## Planning & Zoning Commission Regular Meeting

Wednesday, March 08, 2023 at 6:30 PM

Permit Number 2018-P-1154-PP  
Job Address: Shadowglen Phase 3 Section 1 & 2 Preliminary Plan, Manor, TX. 78653

The first submittal of the Shadowglen Phase 3 Section 1 & 2 Preliminary Plan (*Preliminary Plan*) submitted by Kimley Horn and received on February 10, 2023, have been reviewed for compliance with the City of Manor Subdivision Ordinance 263B.

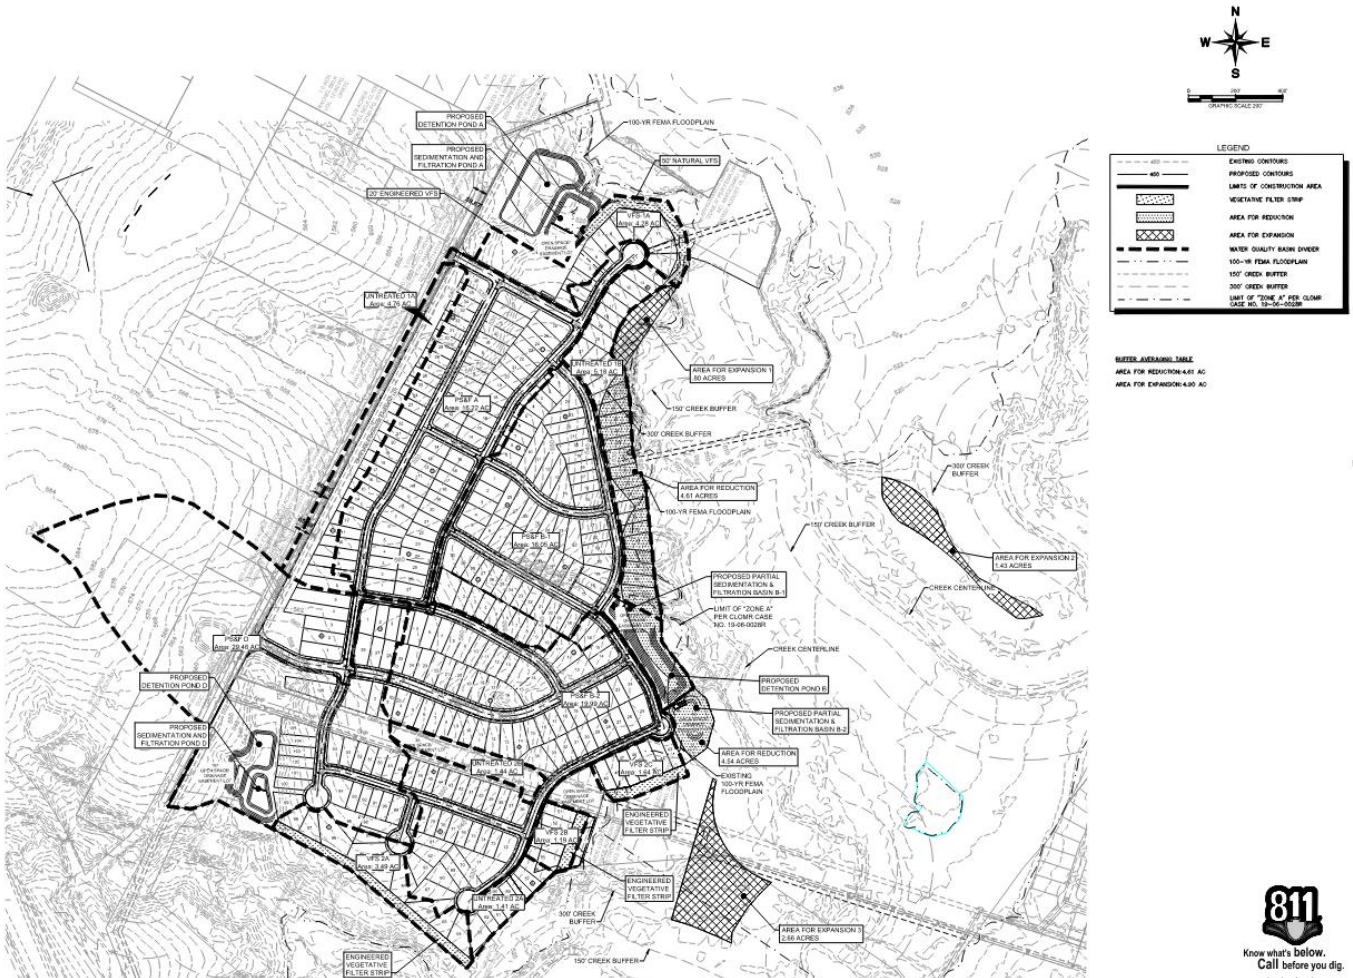
5. An exception request would need to be approved by the Division Director under 482.941.j.7. for the waterway buffer encroachments noted.

Please submit your request for approval.

**Response:** As discussed in our previous comment response a buffer averaging is proposed for the residential lots and Pond B located within the 300' setback per COA ECM 1.5.2.D. The 4.61ac area of reduction shown on Exhibit B will be averaged with three areas of expansion that account for a total of 4.9 acres. See exhibit G below and on sheet 12 of the prelim plan.

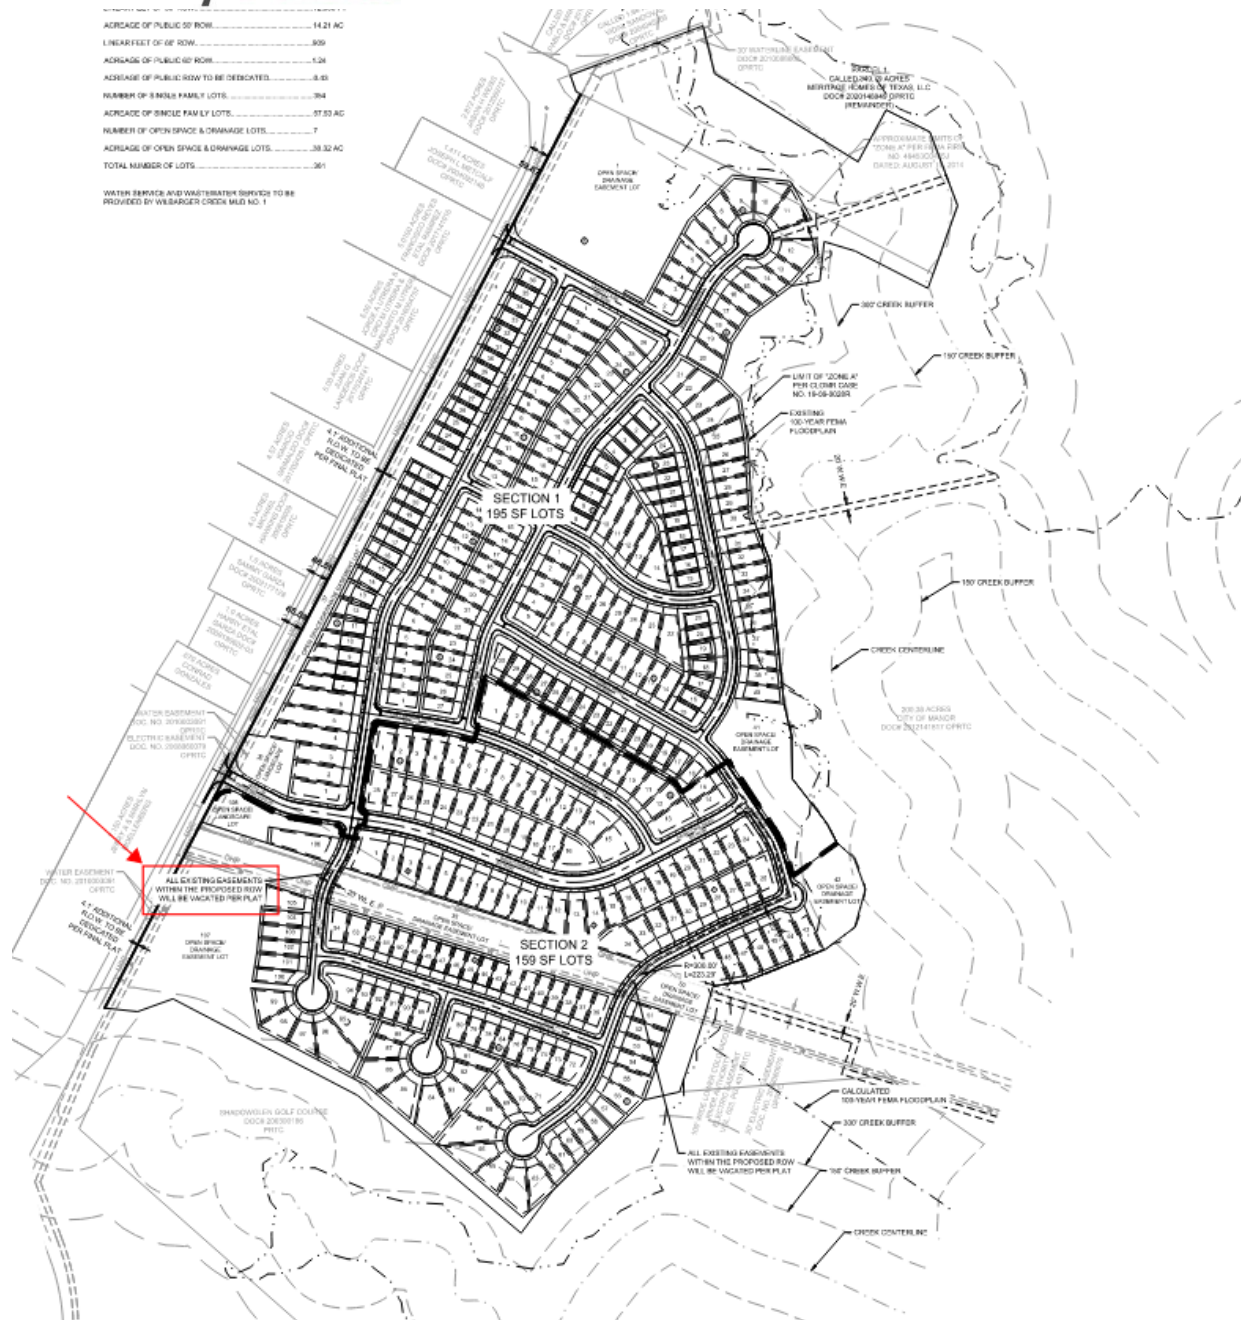
Response 16: Vacation note has been added to the preliminary plan.

Update comment 1/23/23: Please confirm the location of the note; I did not find it on the Preliminary Plan.

**Response: Acknowledged. The vacation note is shown below on the overall preliminary plan.**

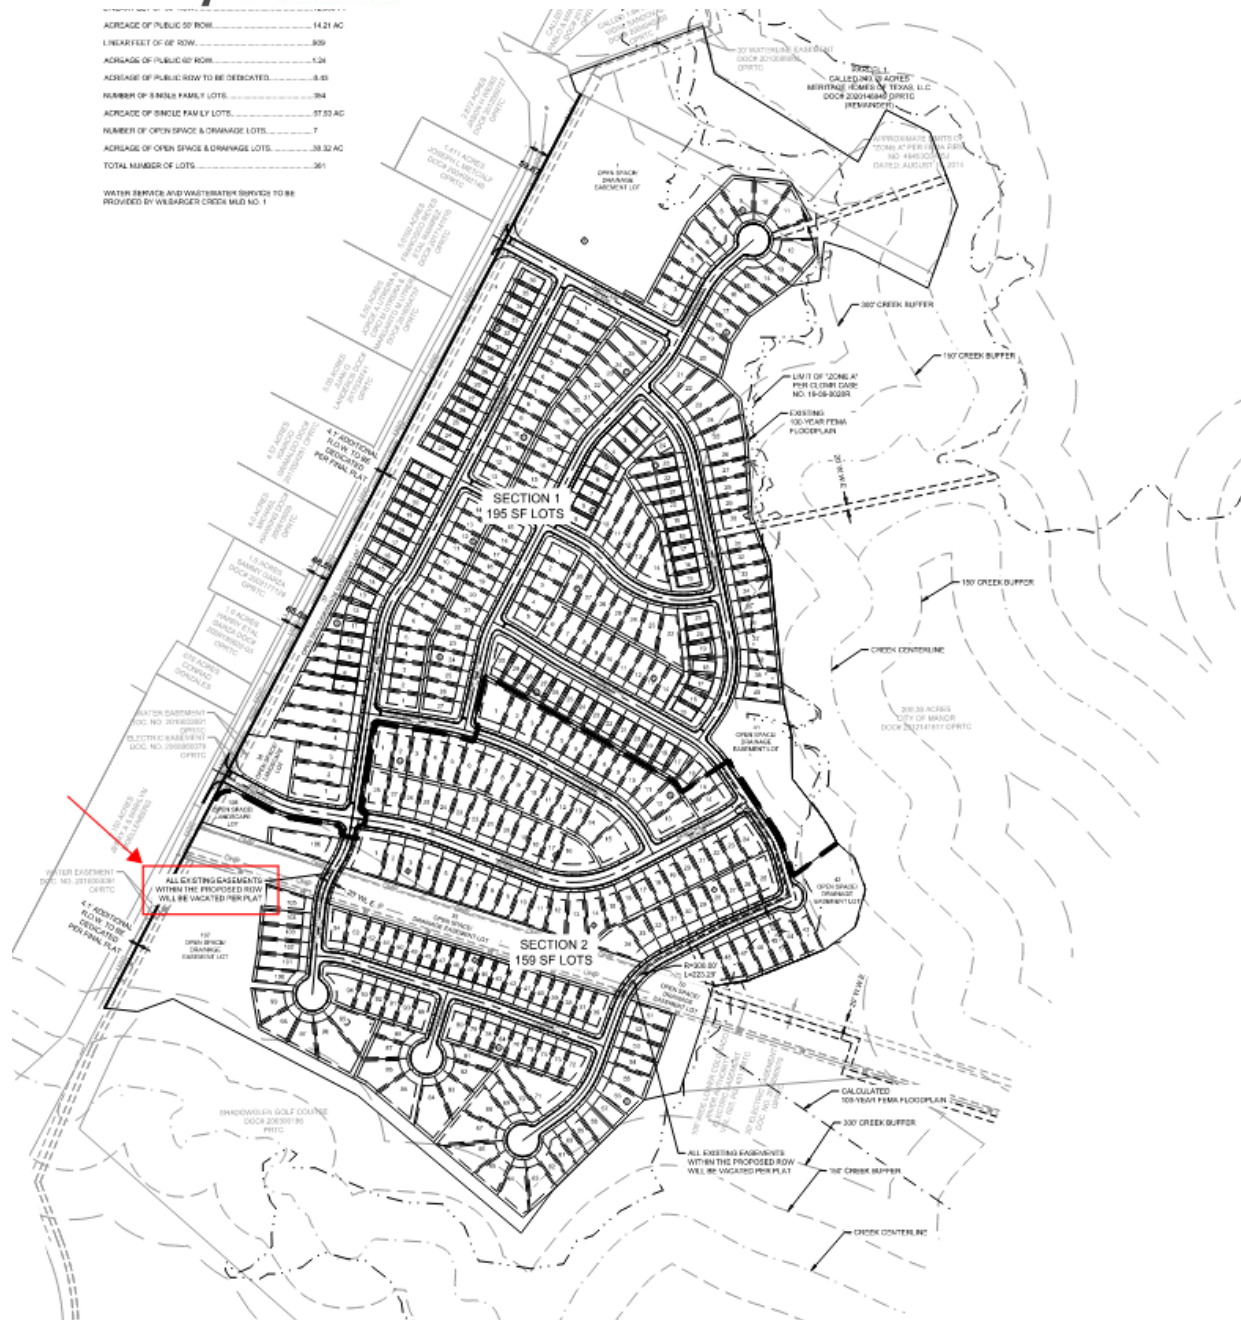
Response 16: Vacation note has been added to the preliminary plan.

Update comment 1/23/23: Please confirm the location of the note; I did not find it on the Preliminary Plan.

**Response: Acknowledged. The vacation note is shown below on the overall preliminary plan.**

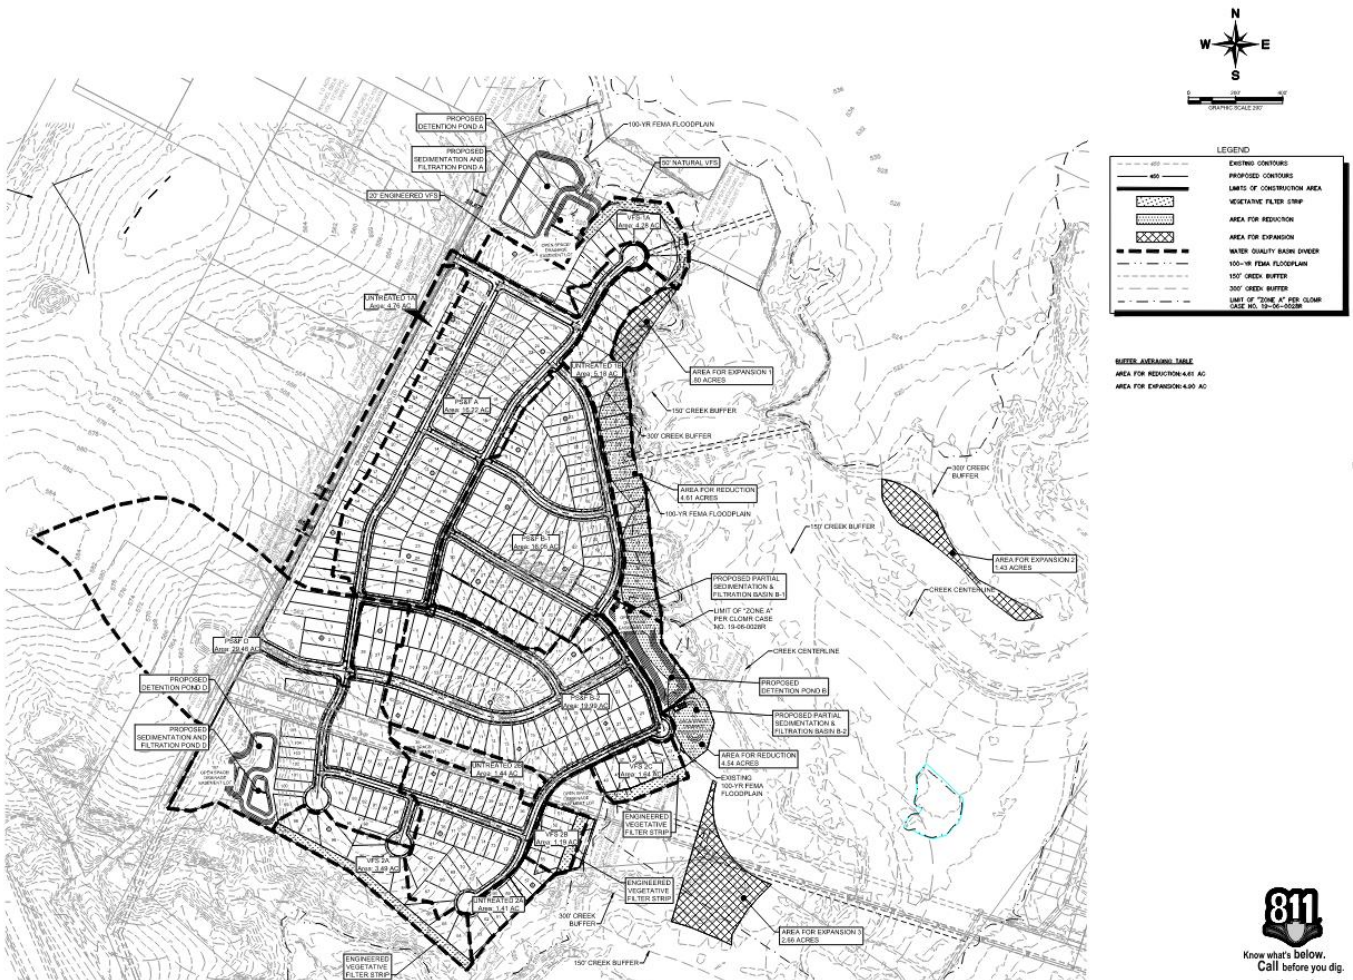
5. An exception request would need to be approved by the Division Director under 482.941.j.7. for the waterway buffer encroachments noted.

Please submit your request for approval.

**Response:** As discussed in our previous comment response a buffer averaging is proposed for the residential lots and Pond B located within the 300' setback per COA ECM 1.5.2.D. The 4.61ac area of reduction shown on Exhibit B will be averaged with three areas of expansion that account for a total of 4.9 acres. See exhibit G below and on sheet 12 of the prelim plan.

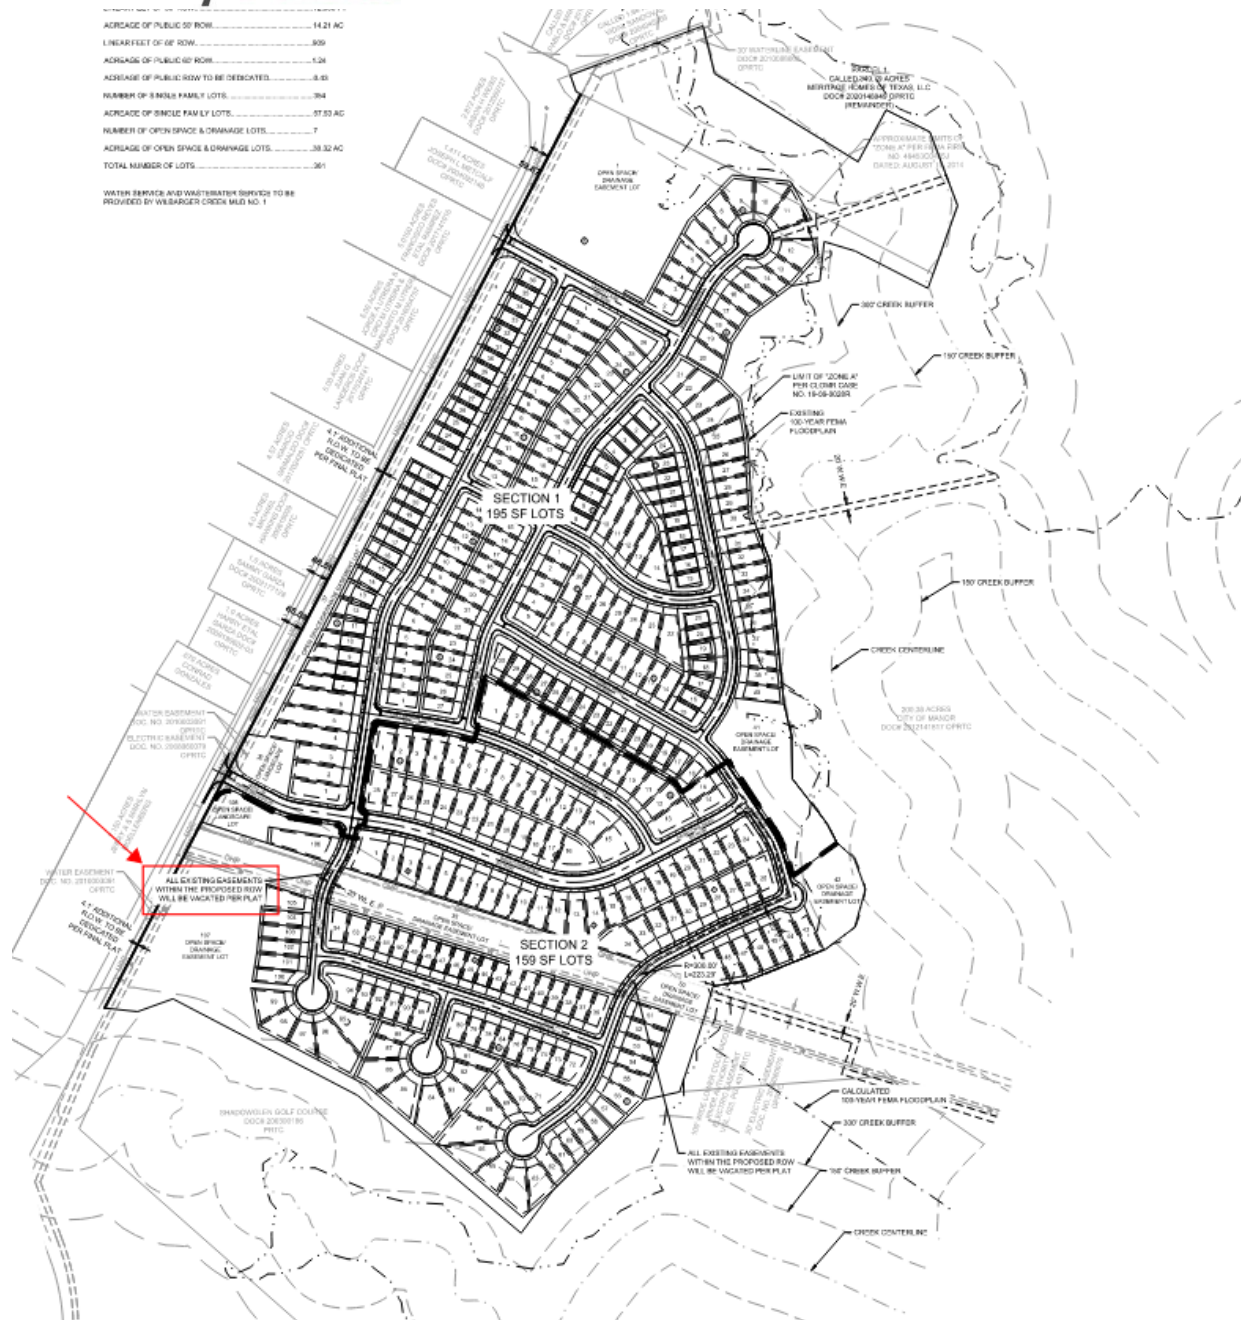
Response 16: Vacation note has been added to the preliminary plan.

Update comment 1/23/23: Please confirm the location of the note; I did not find it on the Preliminary Plan.

**Response: Acknowledged. The vacation note is shown below on the overall preliminary plan.**

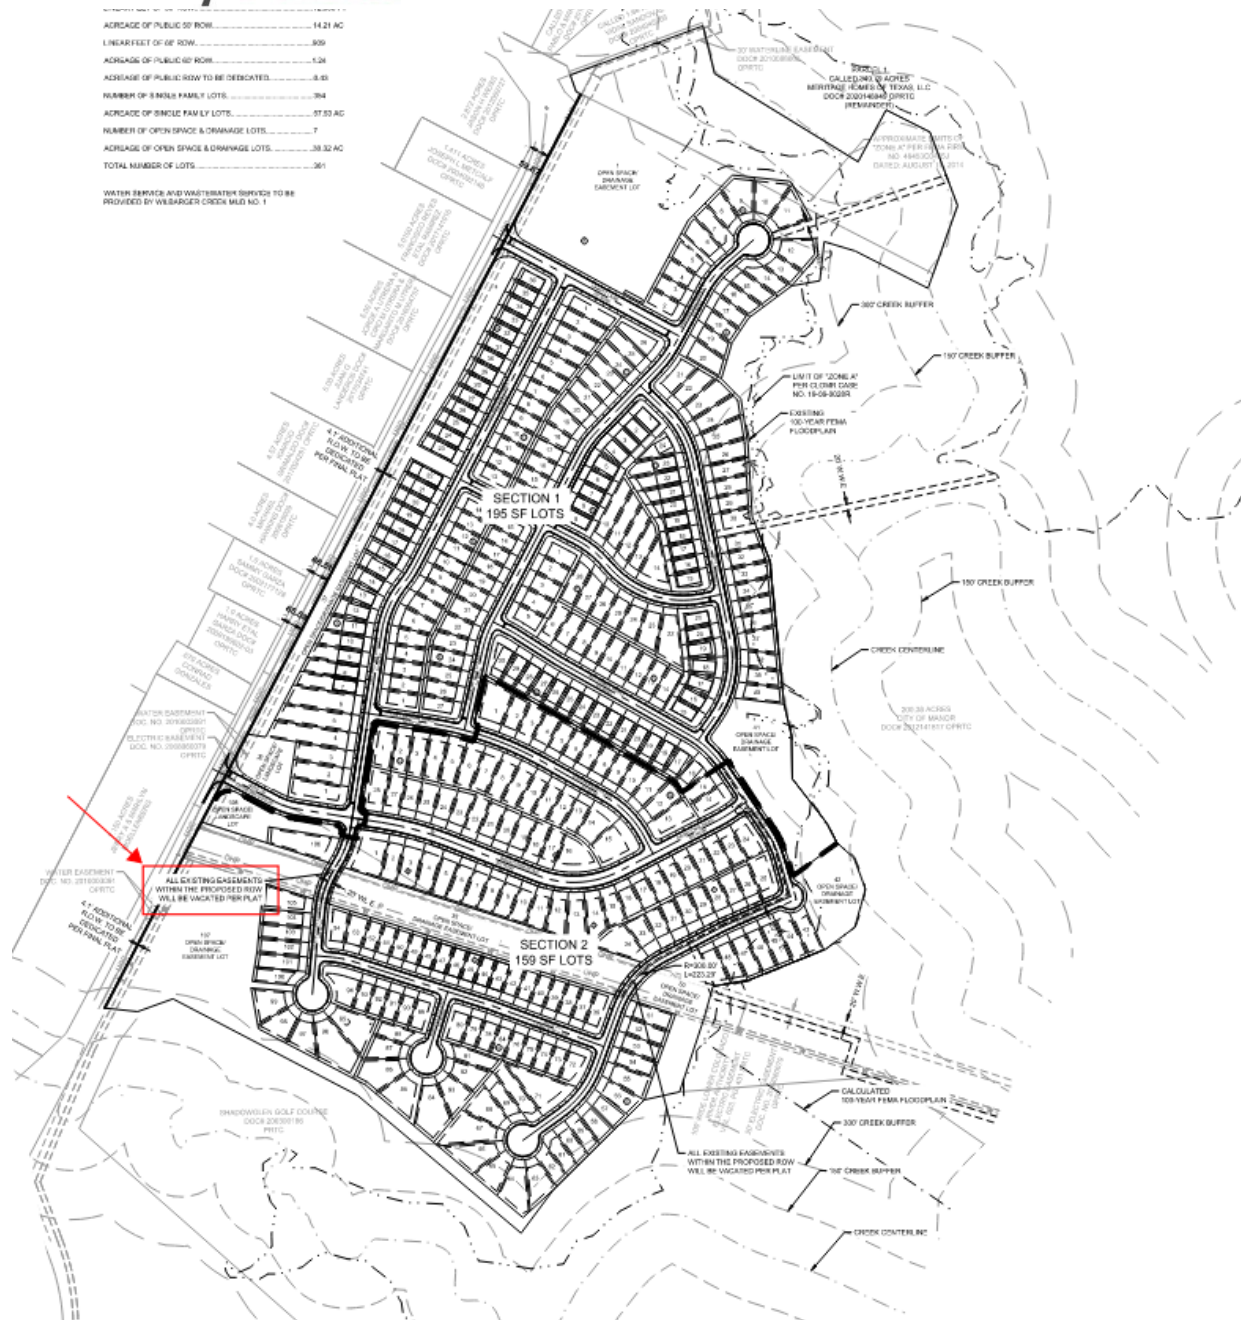
Response 16: Vacation note has been added to the preliminary plan.

Update comment 1/23/23: Please confirm the location of the note; I did not find it on the Preliminary Plan.

**Response: Acknowledged. The vacation note is shown below on the overall preliminary plan.**
